Revised Layout - Some comments about Daylight and Sunlight

Time preclude a detailed analysis of the existing site and the new proposal, however, the impact of the proposed change in some areas is clear. The following notes and diagrams discuss the main likely results of the suggested changes.

Figure 1 Massing diagram Southwark's proposal

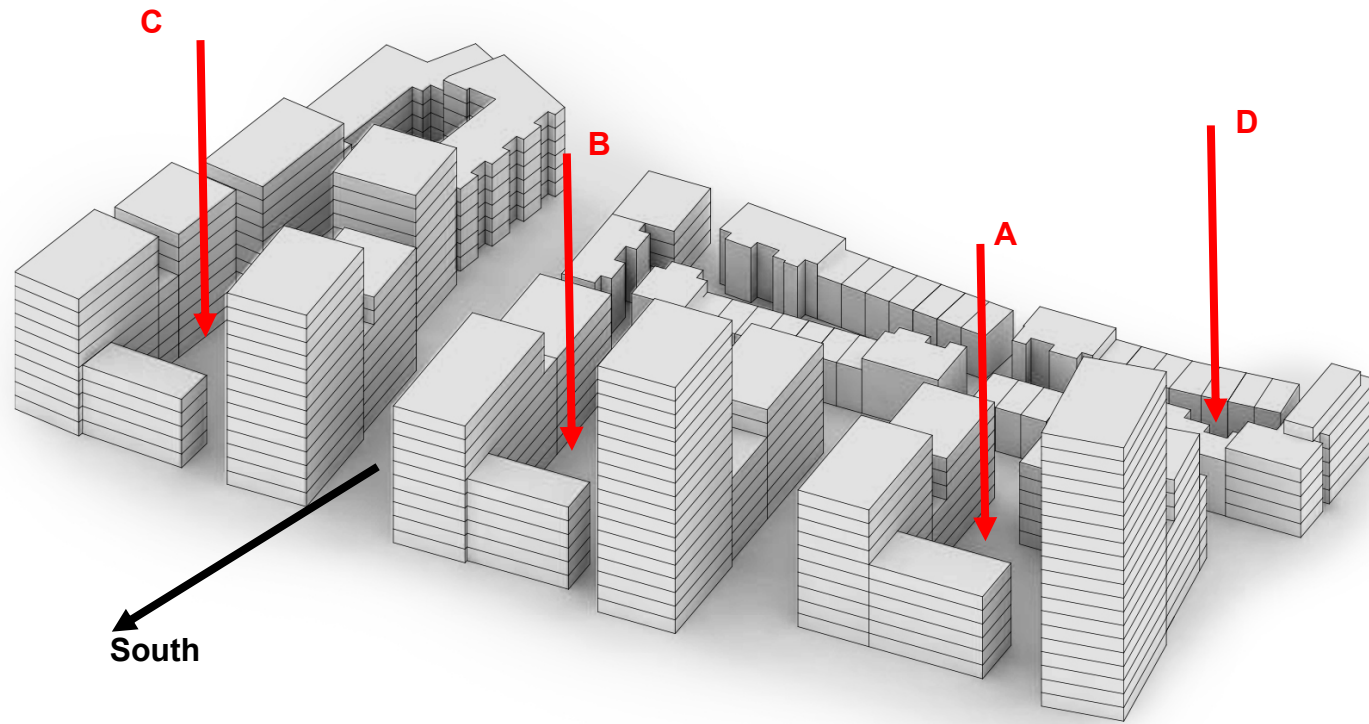
In the current proposal (Fig 1) this area is almost totally surrounded by buildings so that it has become similar in nature to a closed court yard. This restricts the number of hours for which the ground in the area will receive sunlight and also the amount of the sky that can be seen from the windows of (and hence the daylight inside) the flats on the lower floors of the blocks. In the revised proposals (Fig 2 & Fig 3) the area has been opened up by removing the block to the south side of the area. This change will allow sunlight from the south to penetrate to the ground in the area and area of sky visible to the windows of the lower floor flats. To sum up the sunlight and daylight provision in this area is likely to be significantly improved by both of the revised proposals.

In the current proposal (Fig 1) and in revised proposal 1(Fig 2) this area is almost totally surrounded by buildings so that it has become similar in nature to a closed court yard. This restricts the number of hours for which the ground in the area will receive sunlight and also the amount of the sky that can be seen from the windows of (and hence the daylight inside) the flats on the lower floors of the blocks. In the revised proposal 2 (Fig 3) the area has been opened up by removing the block to the south side of the area. This change will allow sunlight from the south to penetrate to the ground in the area and area of sky visible to the windows of the lower floor flats. To sum up the sunlight and daylight provision in this area is likely to be significantly improved by proposal 2 only.

This area suffers from similar problems to areas A & B, however, the revised proposal does not make any changes in this area of the site. To sum up this area of the site has daylight and sunlight problems that are not addressed by the changes in either of the revised proposals.

This area is quite shaded in the original proposal and there are issues with poor sunlight penetration to ground level and poor daylight in rooms on the lower floors. In the revised proposals the building at the eastern end of this area will be taller and hence the shading problems will become worse. The actual impact on the number of hours of sunlight received on 21st March will be small as the sun is on the horizon in the east so even a very short building will cast long shadows and thus it is mainly the building to the south of the area that blocks the sun during the day. The taller building present in options 1 & 2 will reduce the amount of visible sky to the lower windows in the area and thus make some the daylight in some lower rooms a bit worse.

Figure 2 Revised proposal option 1

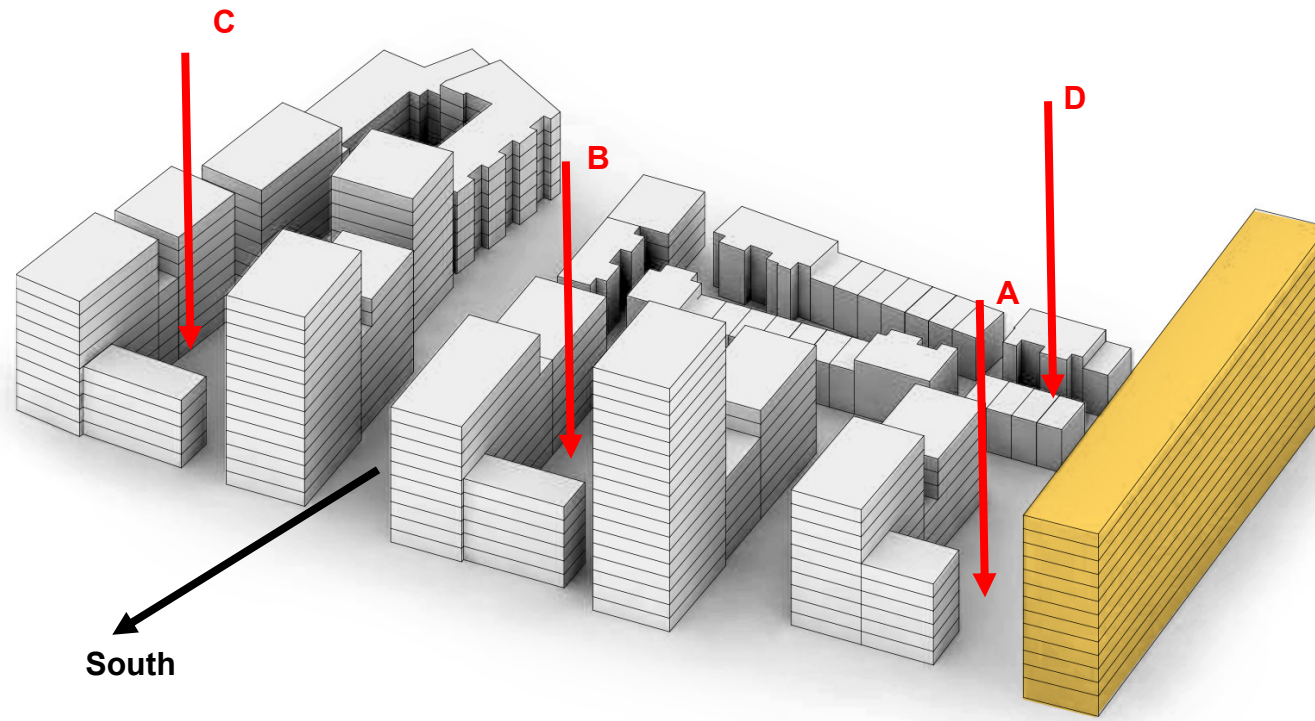
The revised scheme option 1 should make a significant improvement to the daylight and sunlight in area A. In area D the retention of the existing Chiltern block will mean that the daylight and sunlight will get a bit worse. In areas B & C there will be no change in daylight or sunlight.

Figure 3 Revised proposal option 2

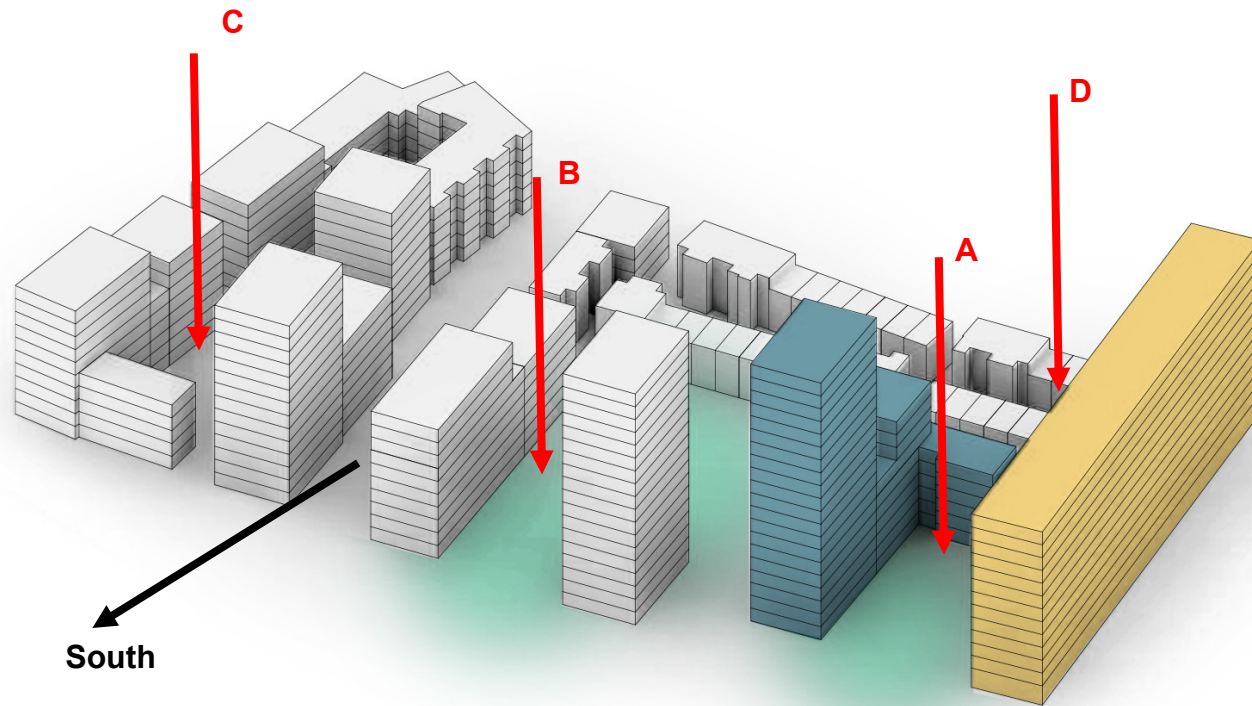
The revised scheme option 2 should make a significant improvement to the daylight and sunlight in areas A & B. In area D the retention of the existing Chiltern block will mean that the daylight and sunlight will get a bit worse. In areas C there will be no change in daylight or sunlight.

In area A both options will give more sunlight hours, in area B this will only be the case with option 2.
